ADDENDUM NO. 03.1

SUBJECT: Addendum No. 03.1 – Public Safety Complex Construction

Project: 19018_COK Public Safety Complex
Date: 24 February 2021

Addendum 03.1 forms a part of Construction Documents and modifies the original drawings and specifications issued on February 1, 2021.

C501

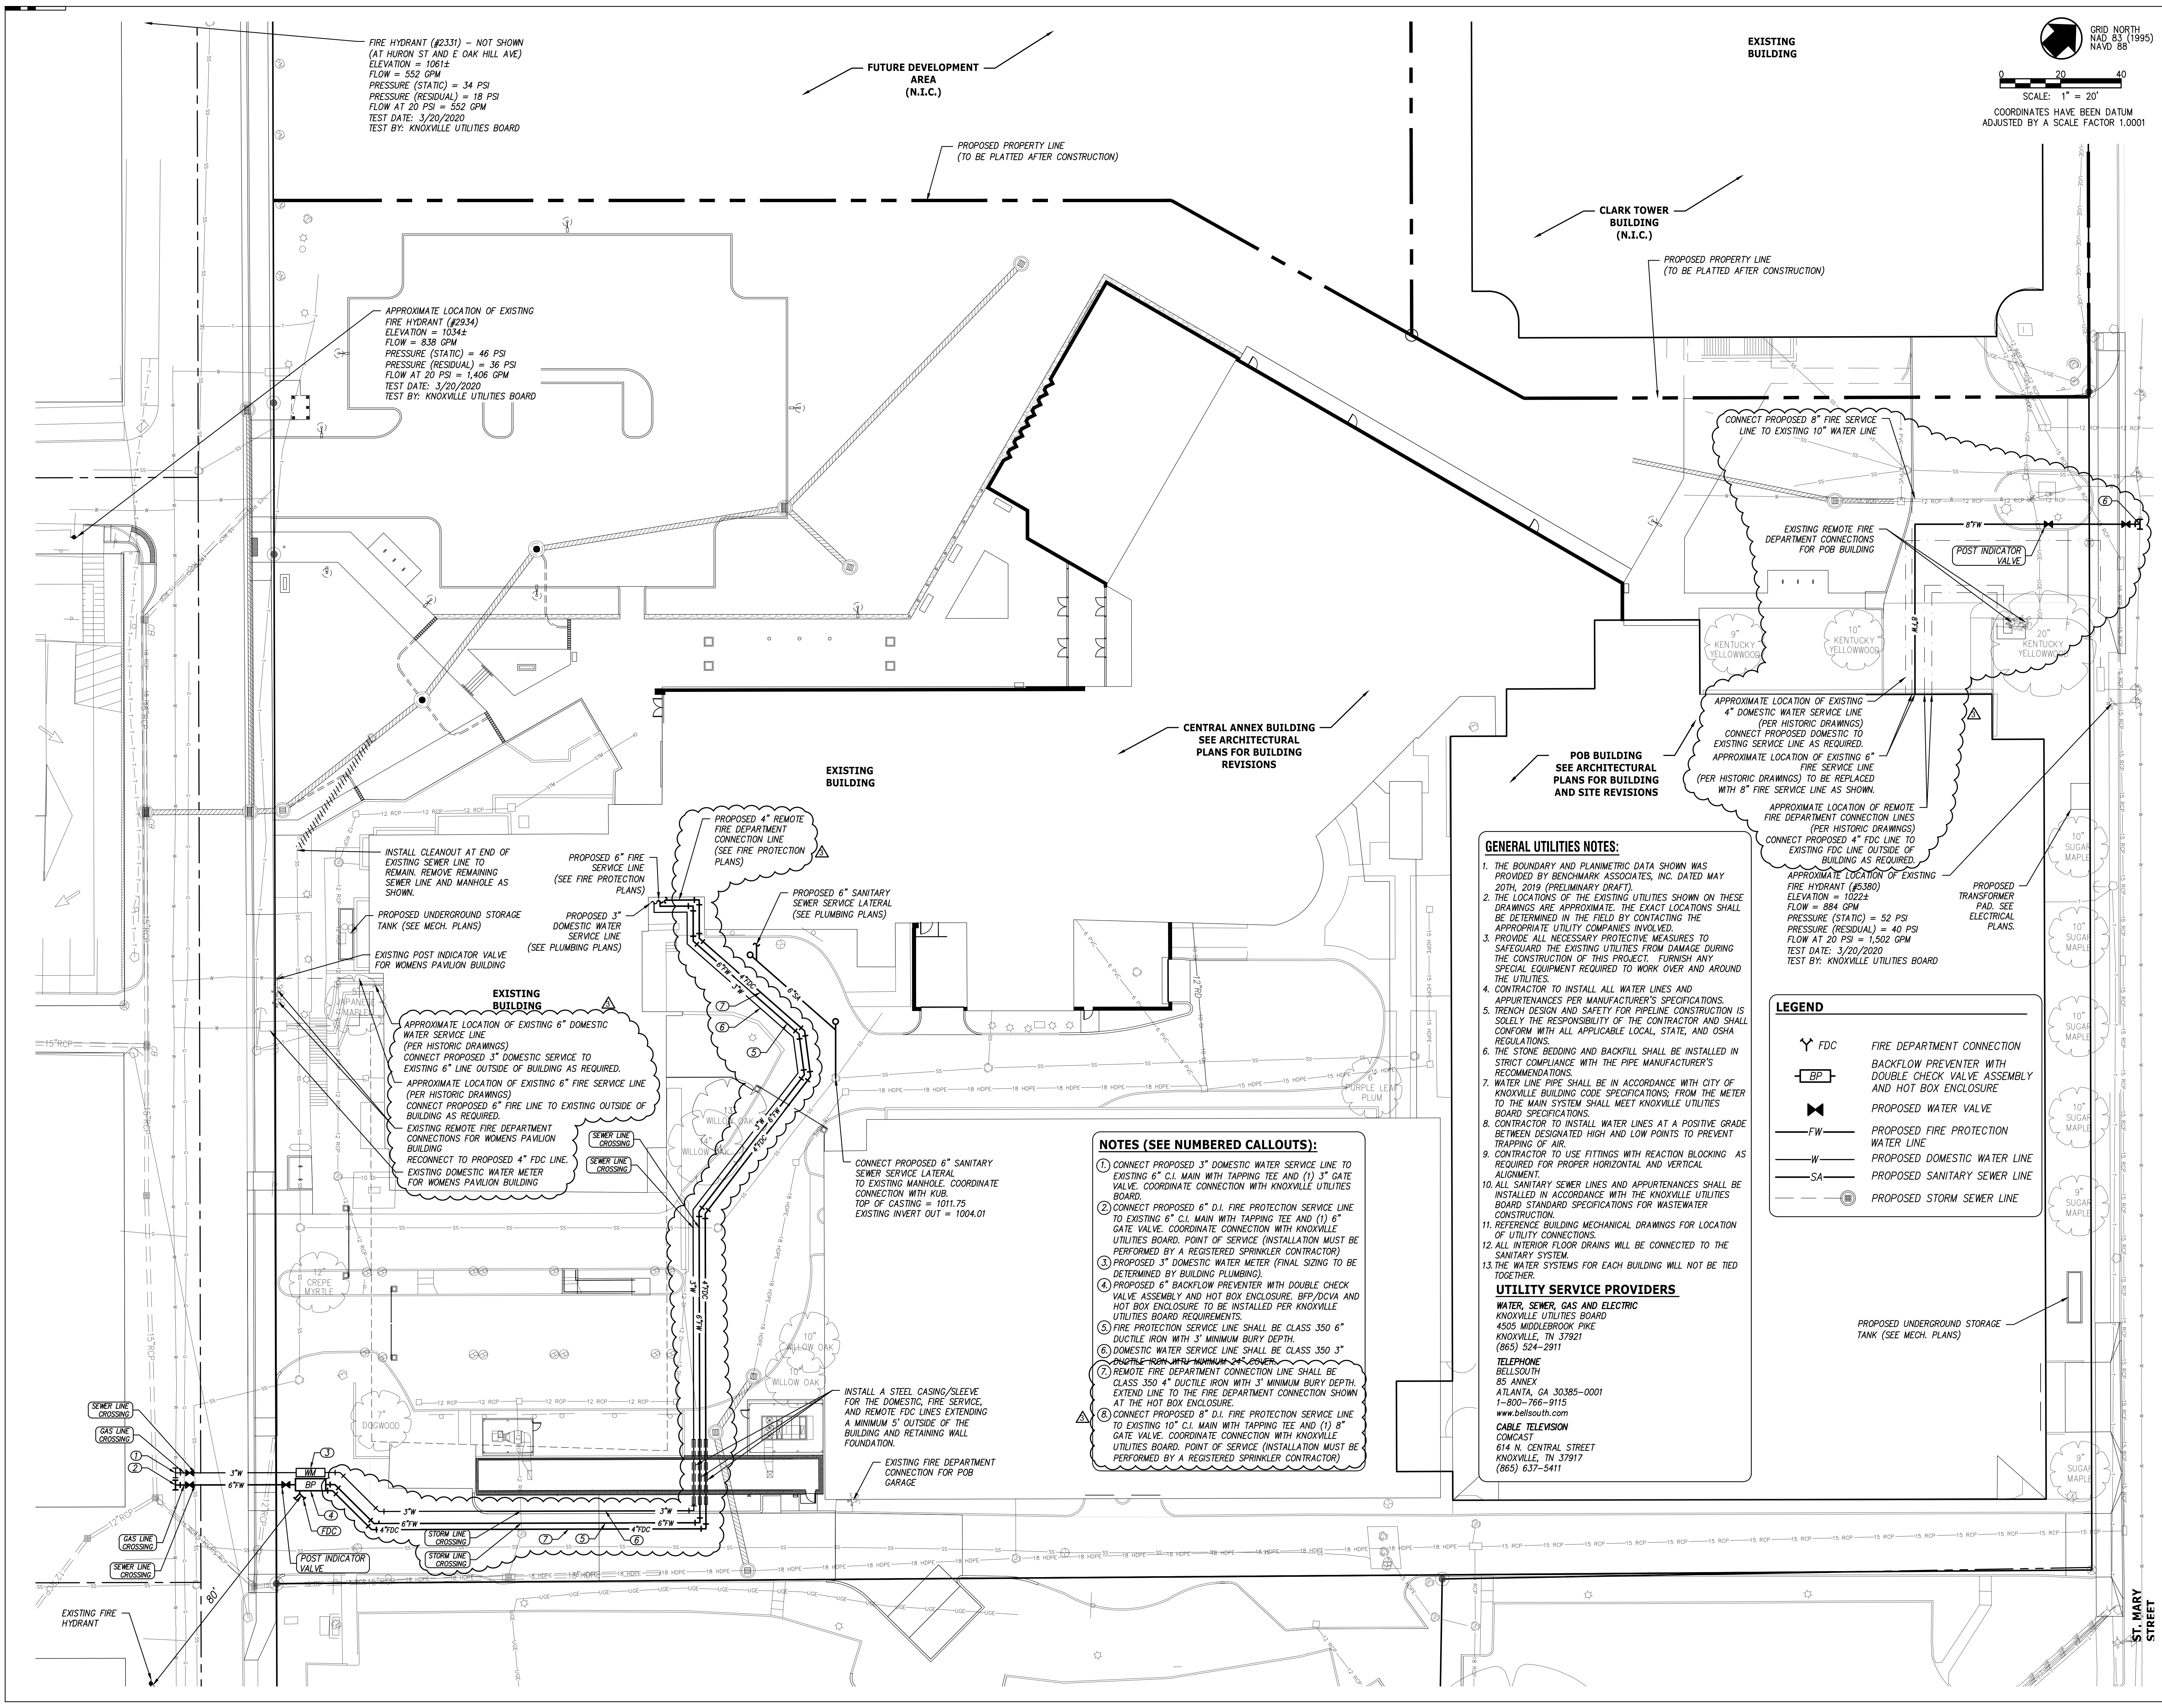
26. Site Fire Line - Civil drawing indicates 6". Drawing FP110.1 indicates 8". Please clarify.
 - a. **This should be a 6" line. Refer to updated drawings.**

A120.3

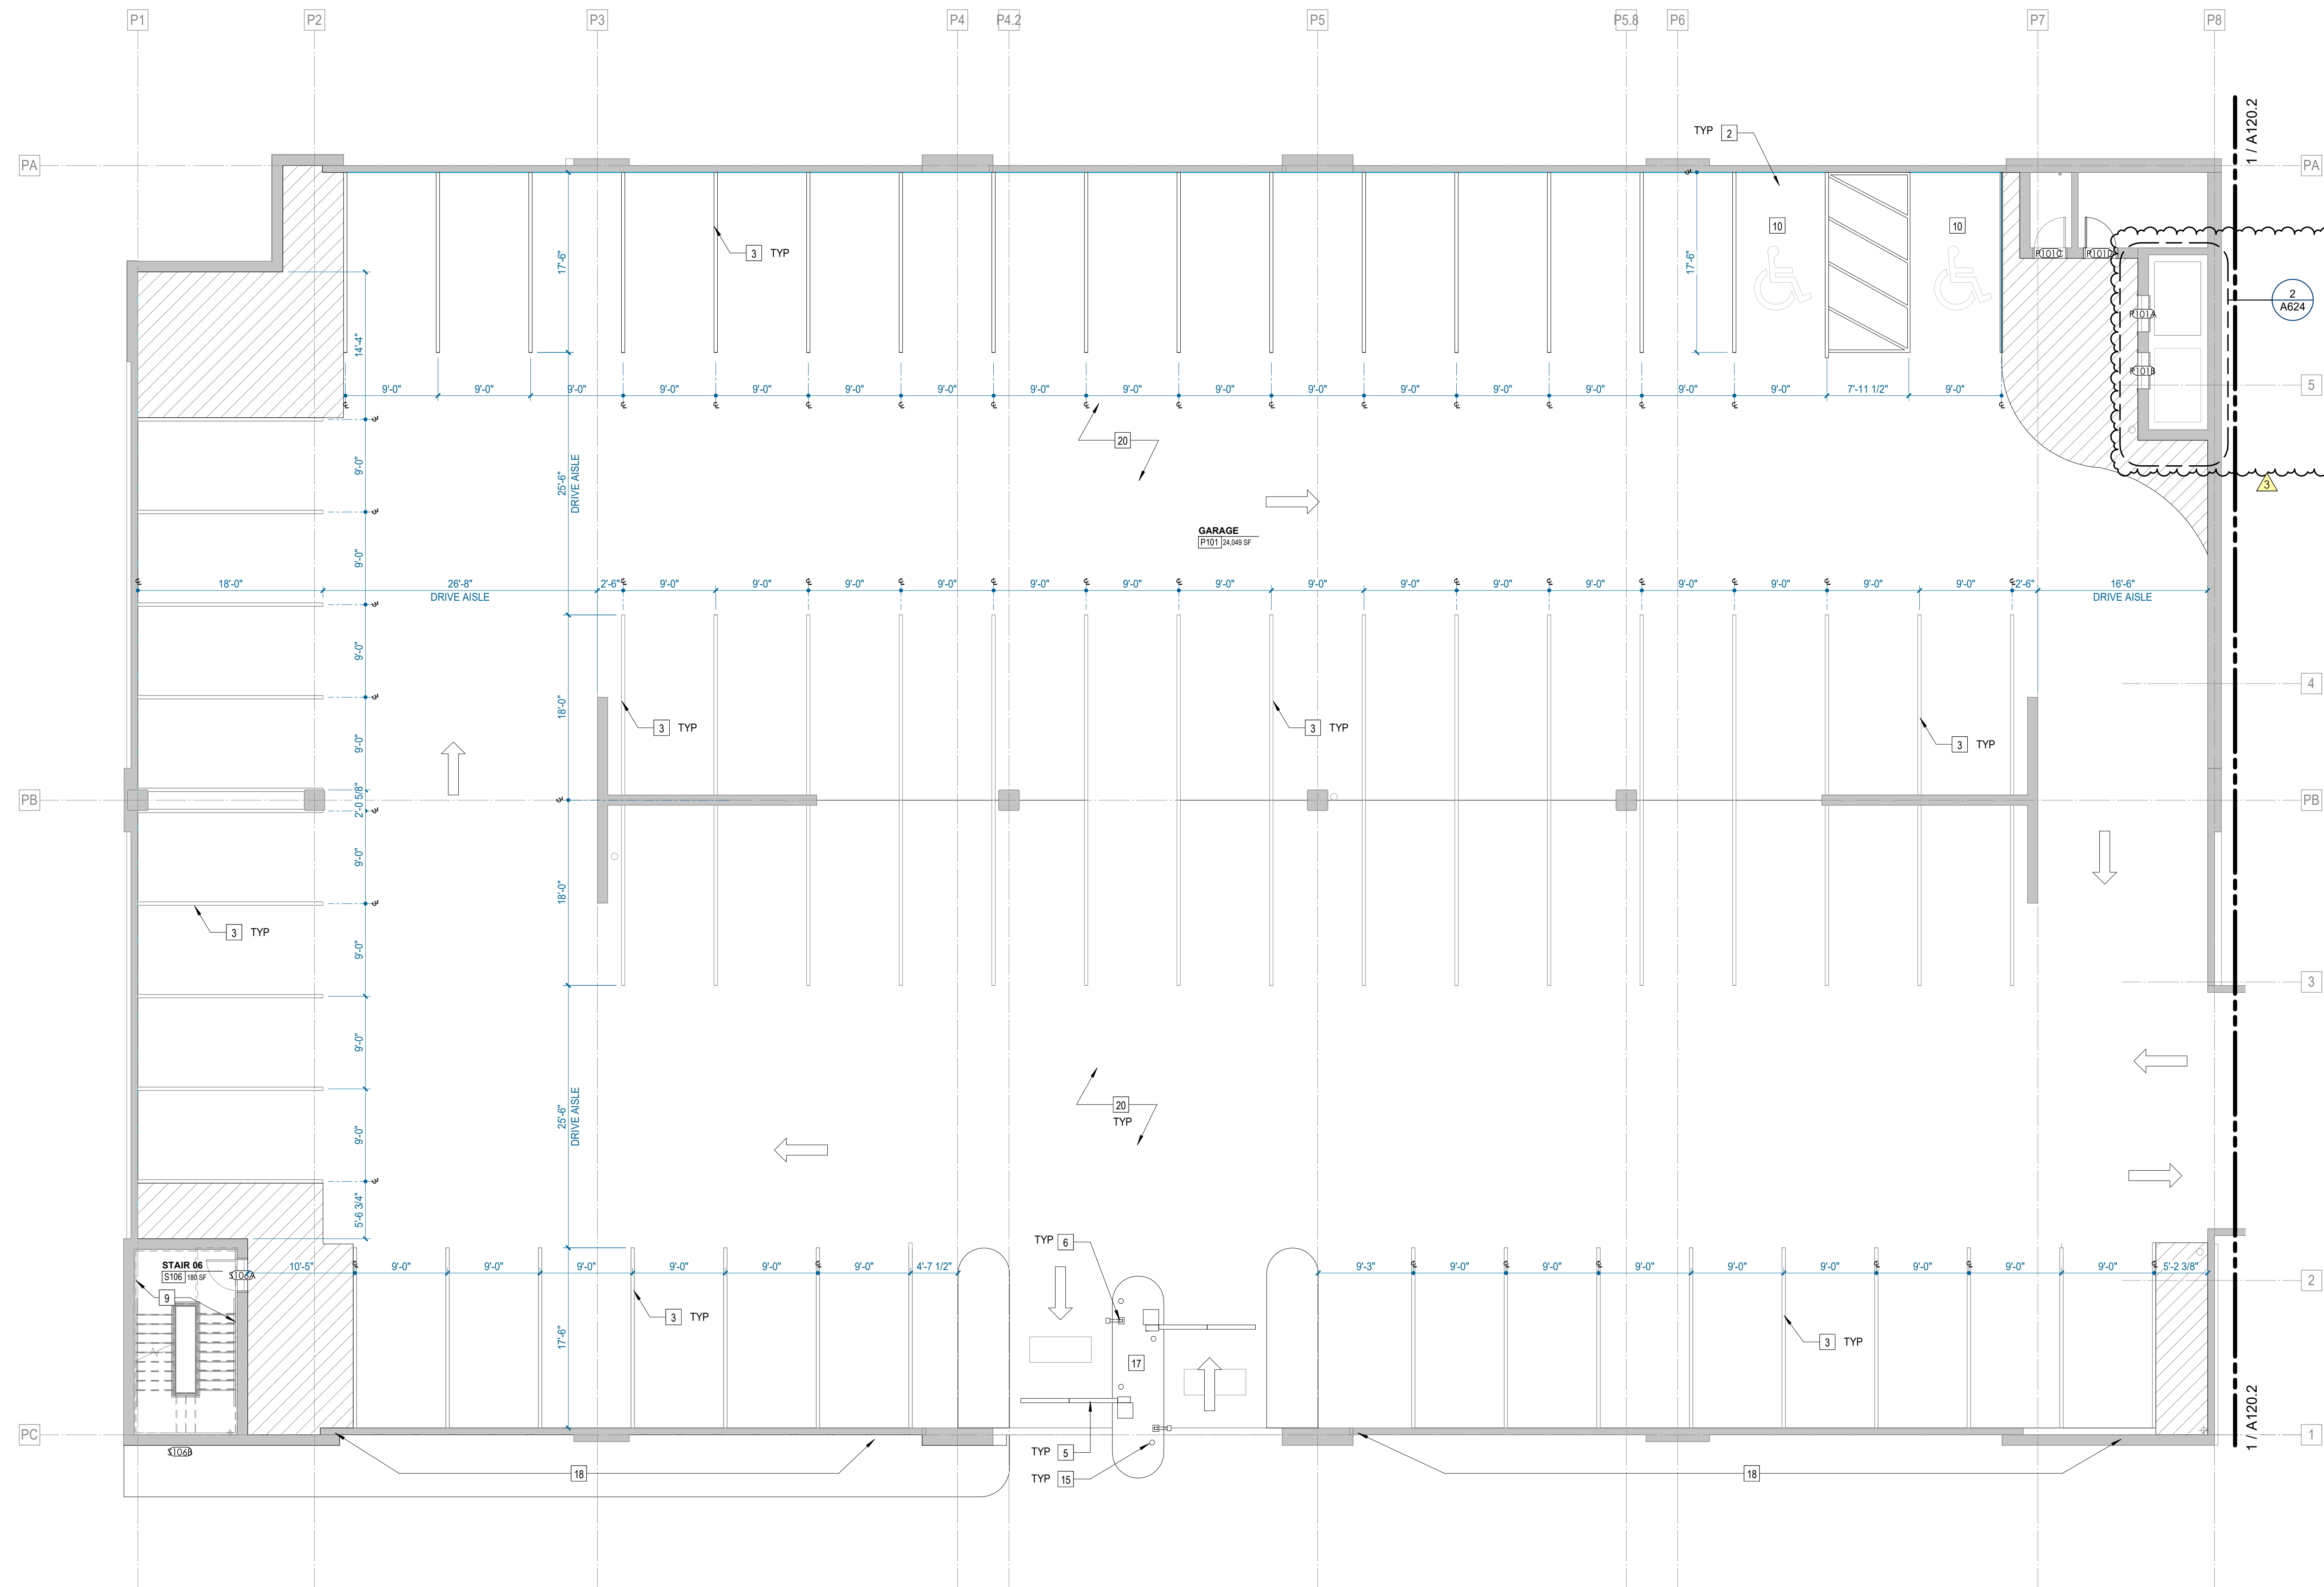
- a. **Refer to revised POB Parking Garage Sheets – notes removed. Refer to Specifications and Sheet A624 for POB Garage Elevator Notes.**
18. A120.3 - Notes 7 & 8 call for one elevator to be refurbished, one elevator to be replaced.

- a. **Refer to revised Sheet A120.3. Notes removed. Refer to Specifications and Sheet A624 for POB Garage Elevator Notes.**
19. We are reviewing the drawings/specs and it appears the scope consists of decommissioning certain elevators and modernizing others.

S110.2

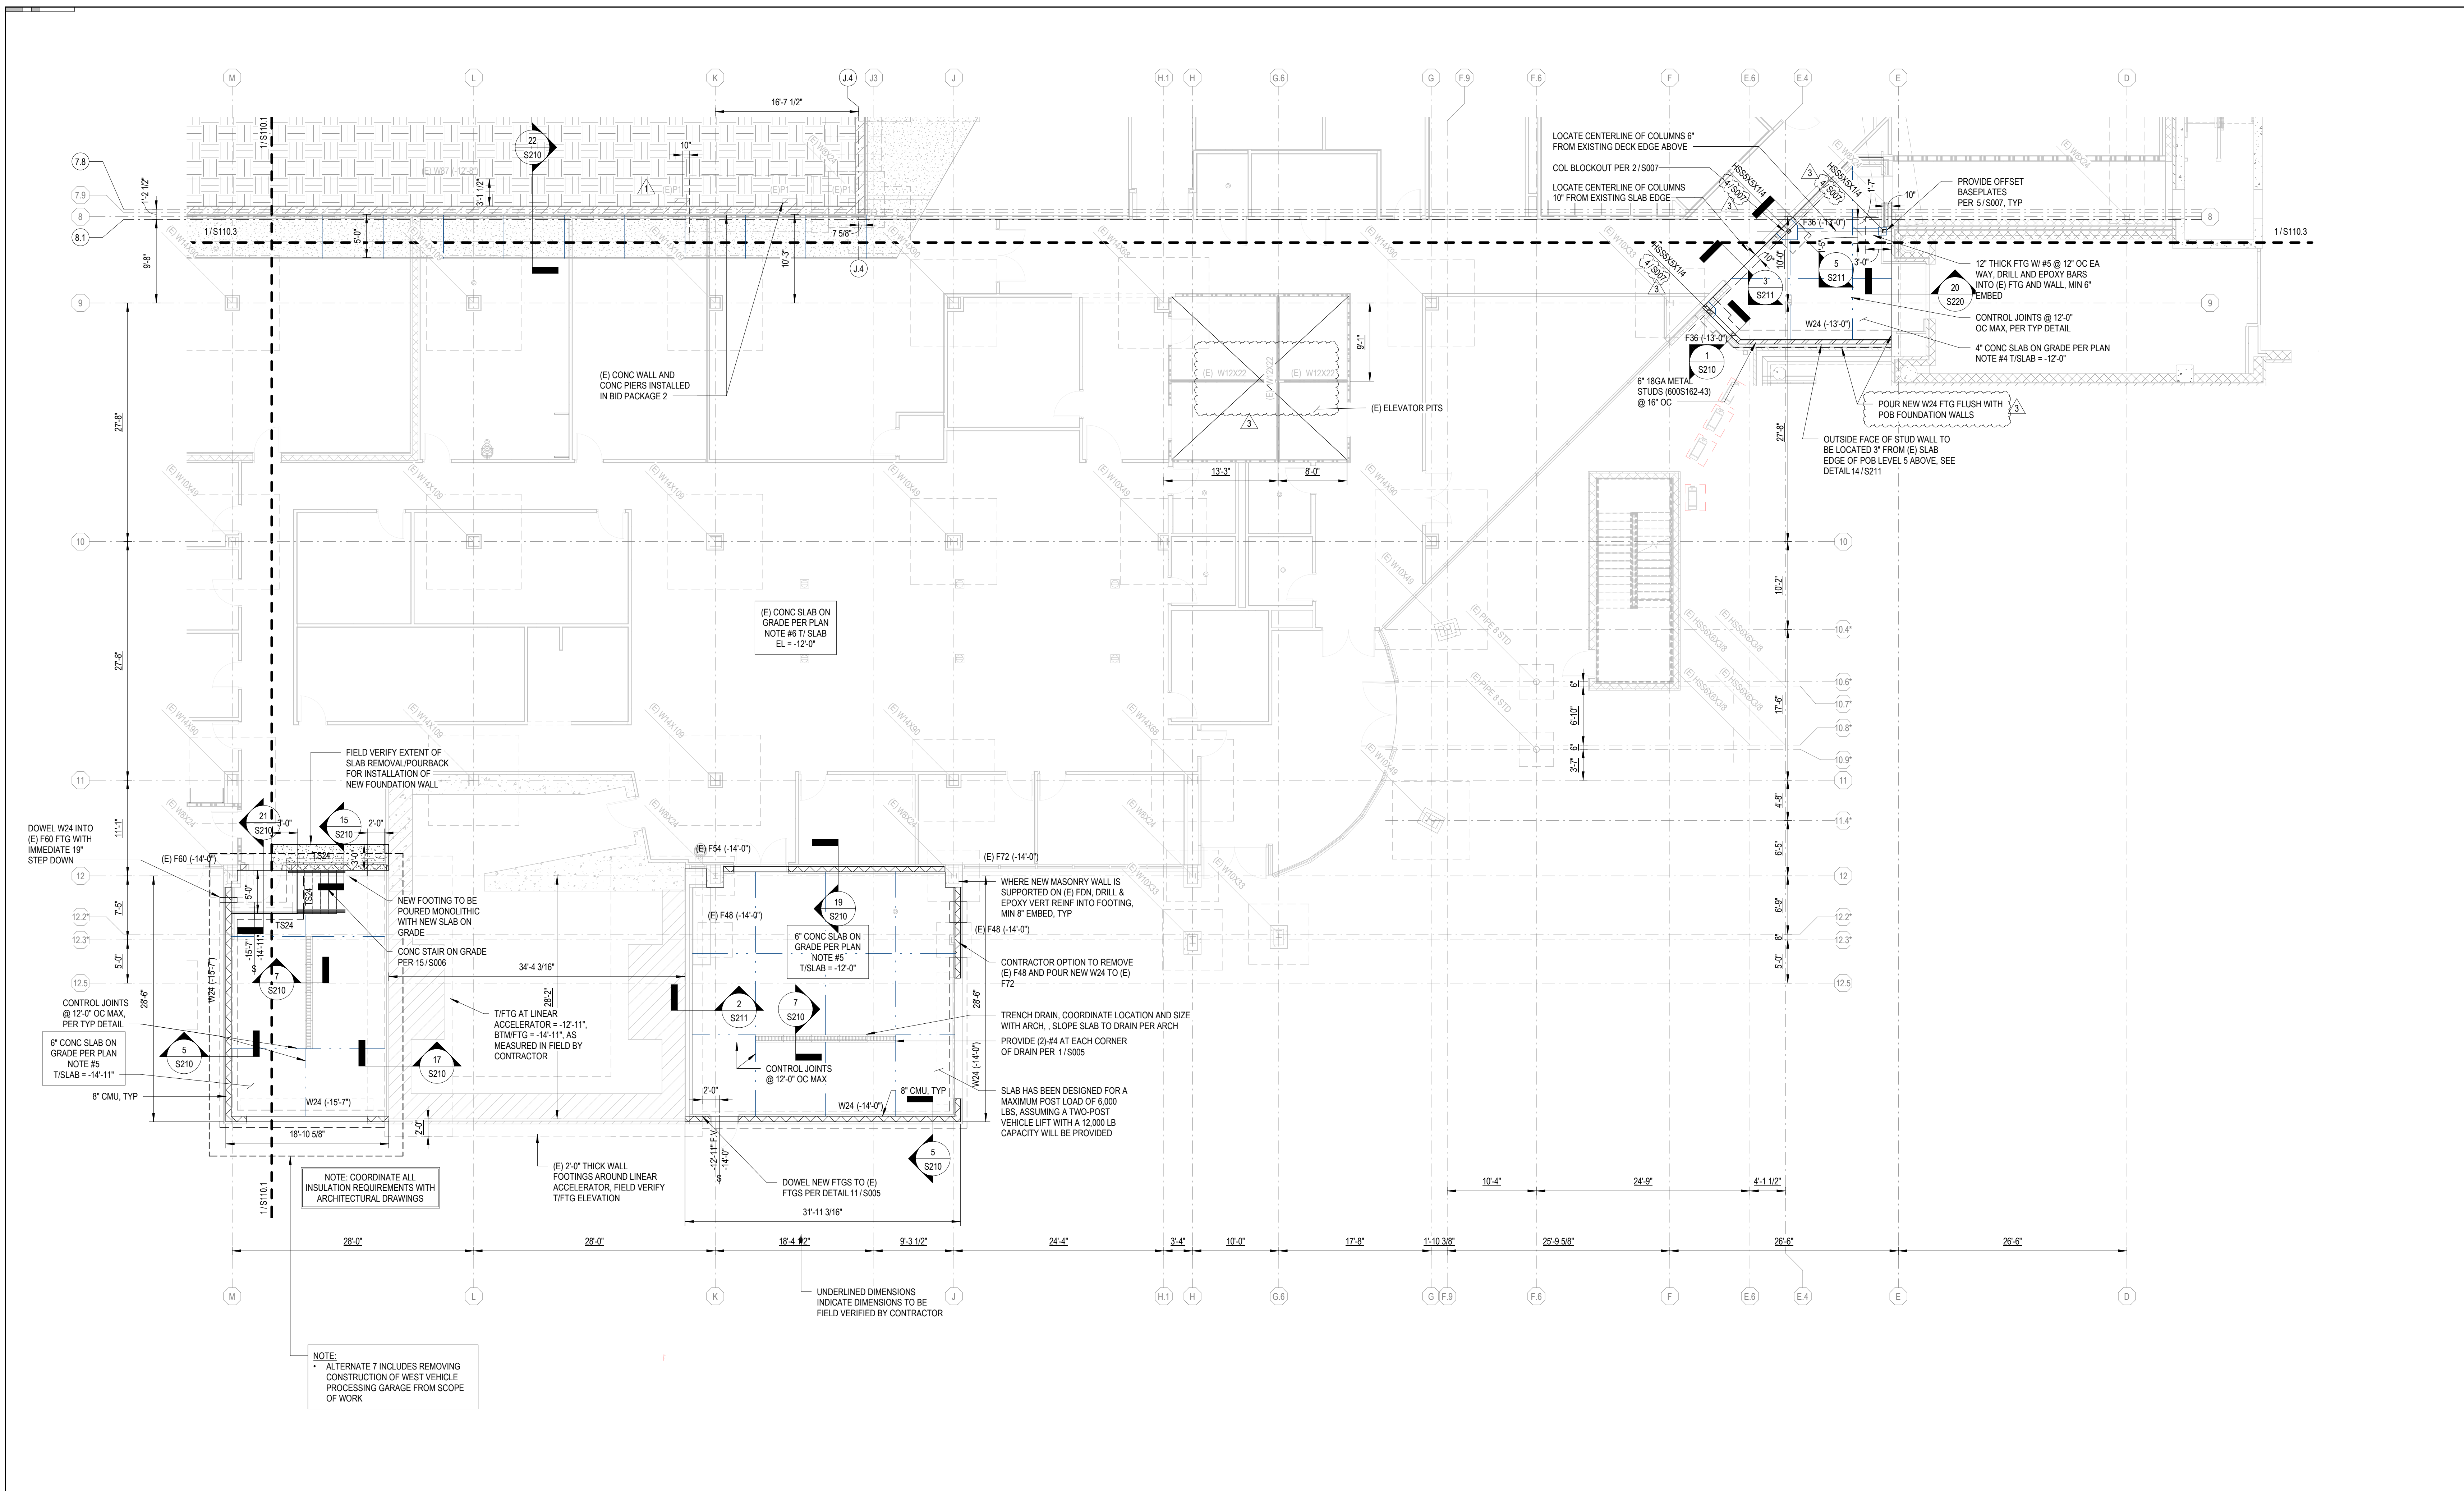
- a. **Blockouts will be in place for all columns within the pour back area that is being poured in BP2.**
74. Drawing S110.2 CA LL3 B. Steel members are shown at the Existing Elevator Pits. Is this new steel in this Bid Package? If so, please provide connection details, etc.
